TO: Northern Beaches Local Planning Panel

Re: Application Number: DA2023/0386

Address: 207-217 Pittwater Rd, Manly

Friday 16th February 2024

2. Solar access.

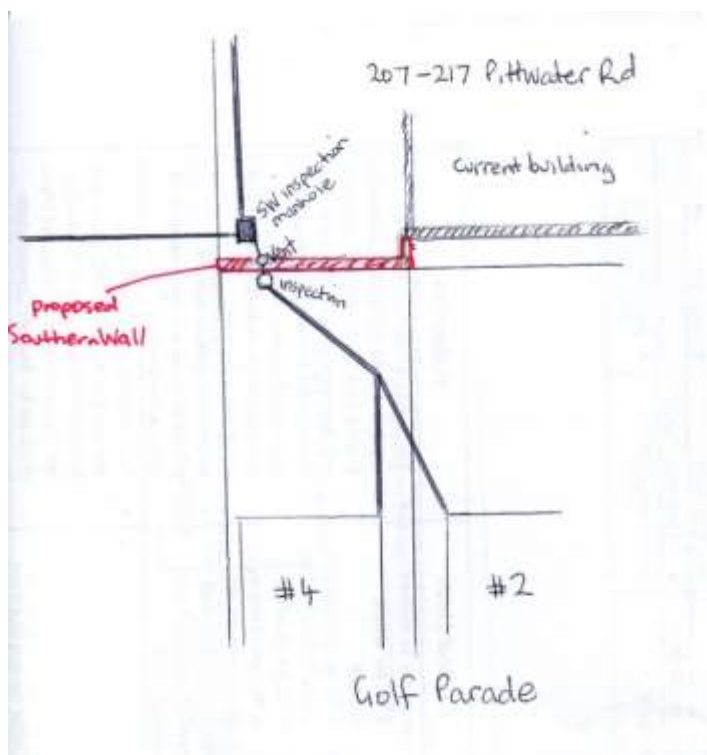
Comment: As the panellists are unable to view the 4 Golf Parade backyard in person, I wish to stress this backyard space is the only functional (for laundry drying and 90+ orchid plants) and recreational space available. The further loss of sunlight will have a huge impact on its use. The backyard is slightly under 6m in depth so any further shadowing beyond what currently occurs will be detriment to this space. Although the developer has reduced the new building height somewhat from the original height which was the same as the existing high building, they have refused to entertain the 900mm set back which is important on the southern boundary to minimise further shadowing.
